RE: KEMBLA GRANGE RESOURCE RECOVERY FACILITY

This submission has been prepared by Patrick Autocare (PAC) to address the Response to Submissions Report (Report) prepared by TCG Planning (TCG) on Behalf of Bicorp Pty Ltd and updated Air Quality Assessment by GHD (April 2015). PAC operates the site at 17 Reddalls Road and 66 West Dapto Road as a vehicle storage facility. We remain concerned that the proposal at the Kemplra Grange Resource Recovery Facility (KGRRF) will have unacceptable environmental impacts on staff and operations.

Figure 17 – Predicted –Annual dust deposition (with mitigation) g/m²/month

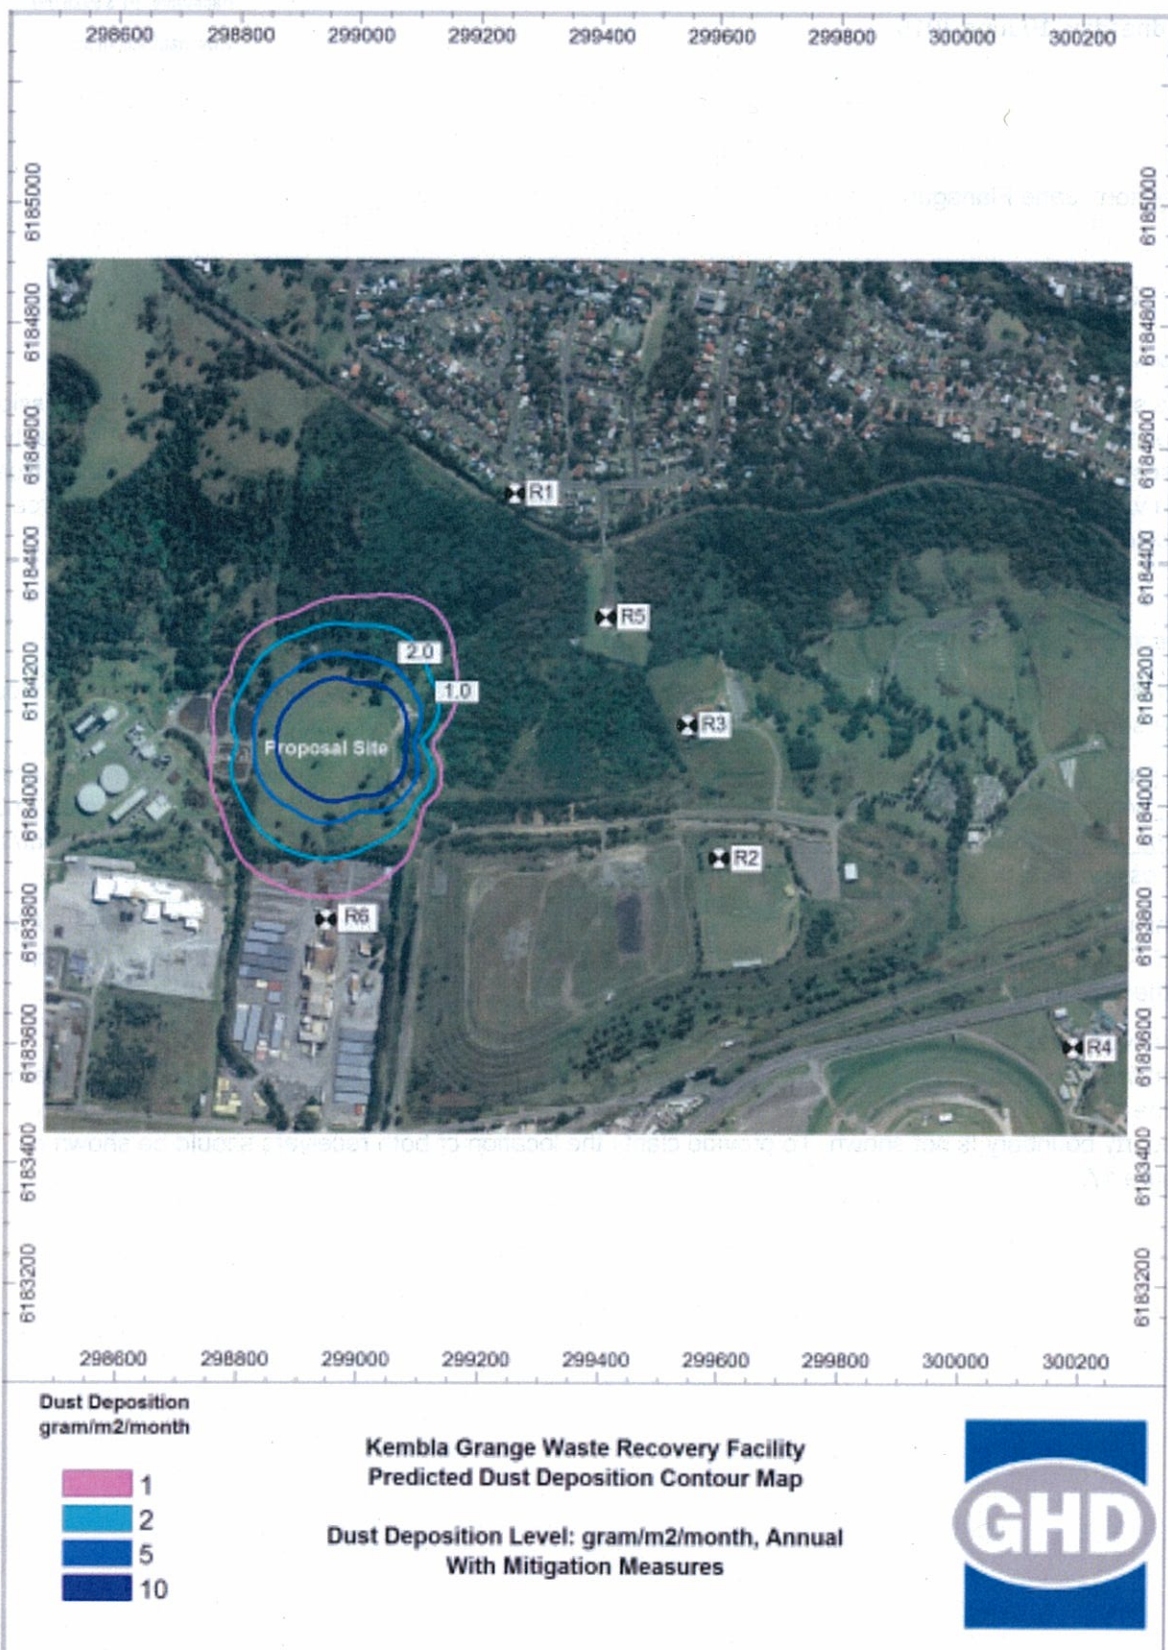
However Figure 17 of the GHD assessment *"Predicted Annual dust deposition (with mitigation) g/m2/month"* (included below) shows the location of the PAC Sensitive Receiver "R6" on the northern end of the site's building. The location of the dust receiver identified in the text as being on the northern property boundary is not shown. To provide clarity the location of both receivers should be shown on Figure 17.

Figure 15 – Predicted – Cumulative PM₁₀ 24-hour Average Concentration (with mitigation) $\mu\text{g}/\text{m}^3$

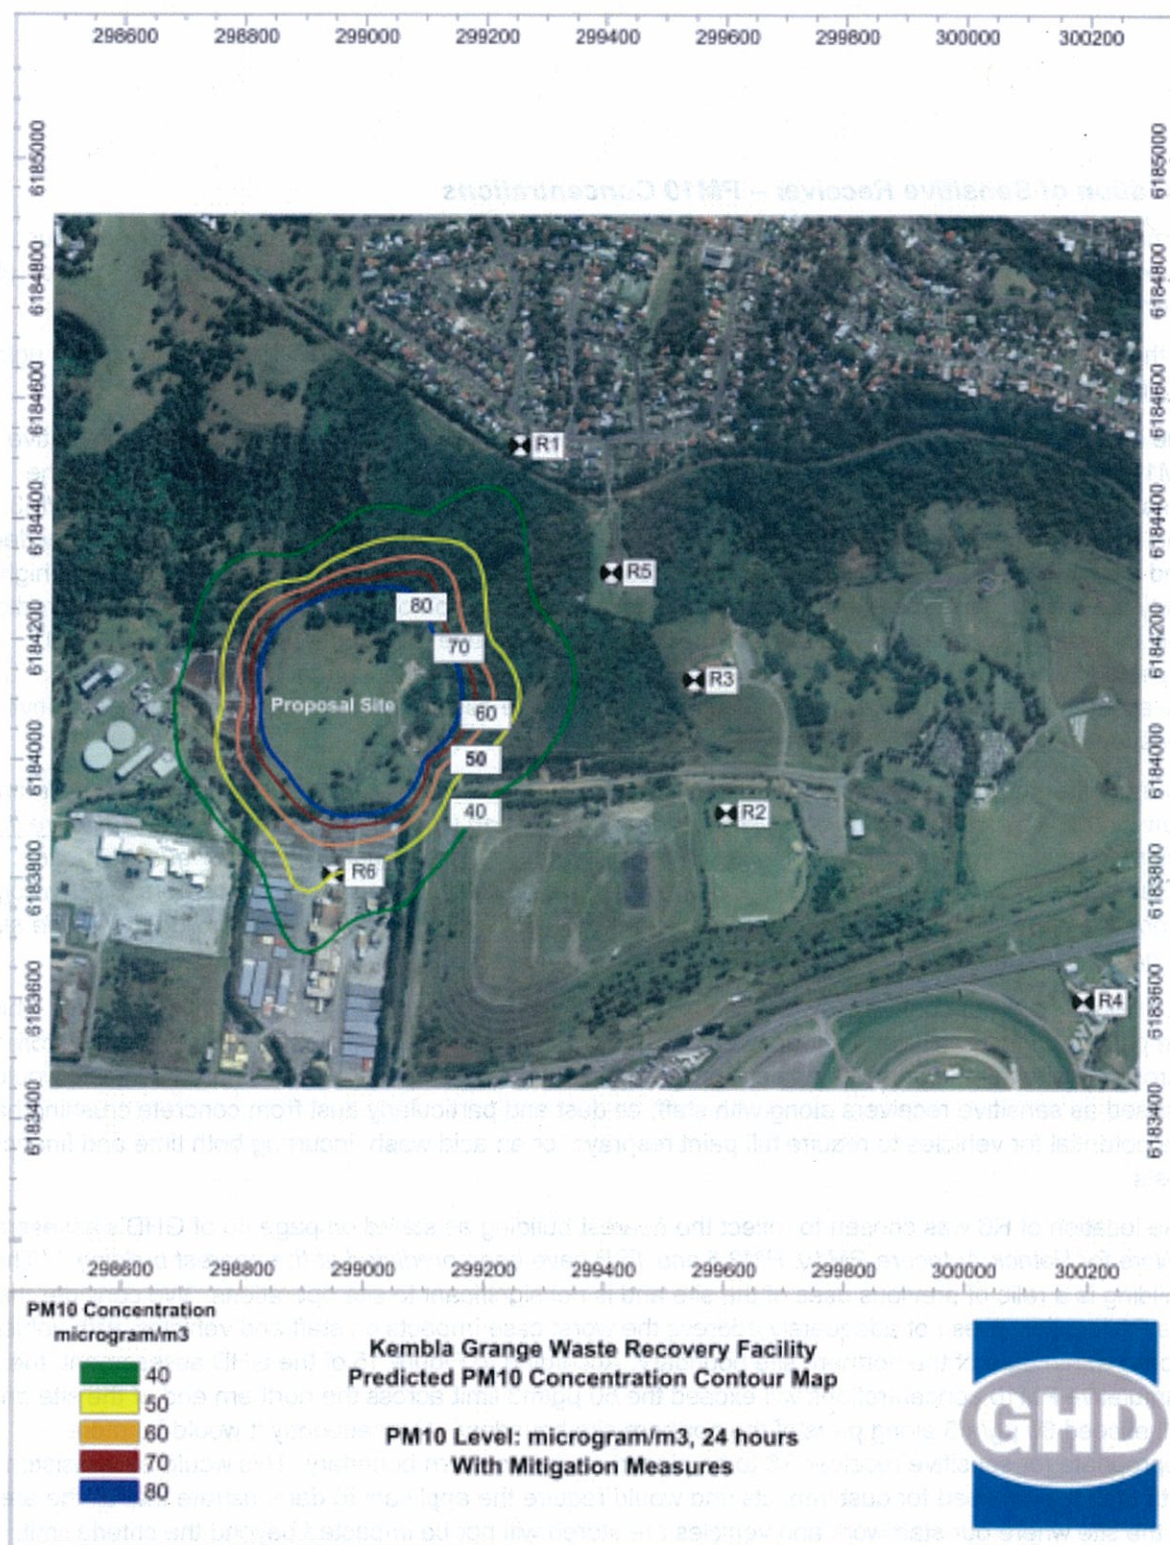
The borderline PM10 result is confirmed by Figure 15 of the GHD assessment "Predicted Cumulative PM10 24-hour Average Concentration (with mitigation) µg/m³" (included below). The location of the sensitive receiver "R6" appears to be located on the PM10 cumulative impact contour level 50 µg/m³. This contour level defines the area of impact within which the PM10 impact criteria would be exceeded. Had the sensitive receiver R6 been located 10 metres further west or north, Figure 15 shows it is highly likely the criteria would be exceeded. GHD modelled a location on our northern boundary when predicting dust deposition impacts. Had GHD used the same "conservative" assumption for predicting PM10 impacts, it would have exceeded the criteria. We do not have confidence that the Air Quality Assessment's results are valid when the conclusions of the assessment appear to be highly sensitive to variations in the location of the sensitive receiver.

The location of R6 was chosen to reflect the nearest building as stated on page 40 of GHD's assessment "**Note for Patrick Autocare PM10, PM2.5 and TSP have been predicted at the nearest building.**". That building is a relic of previous uses of the site and is not significant to site operations. We consider that the R6 location does not adequately address the worst case impacts on staff and vehicles, with vehicles stored within 30m of the northern site boundary. According to Figure 15 of the GHD assessment, the cumulative PM10 concentrations will exceed the 50 µg/m³ limit across the northern end of the site and will exceed 80 µg/m³ along parts of the northern site boundary. Consequently it would be more appropriate for sensitive receiver R6 to be placed on the northern boundary. This would be consistent with the location used for dust impacts and would require the applicant to demonstrate that all the areas of the site where our staff work and vehicles are stored will not be impacted beyond the criteria limit.
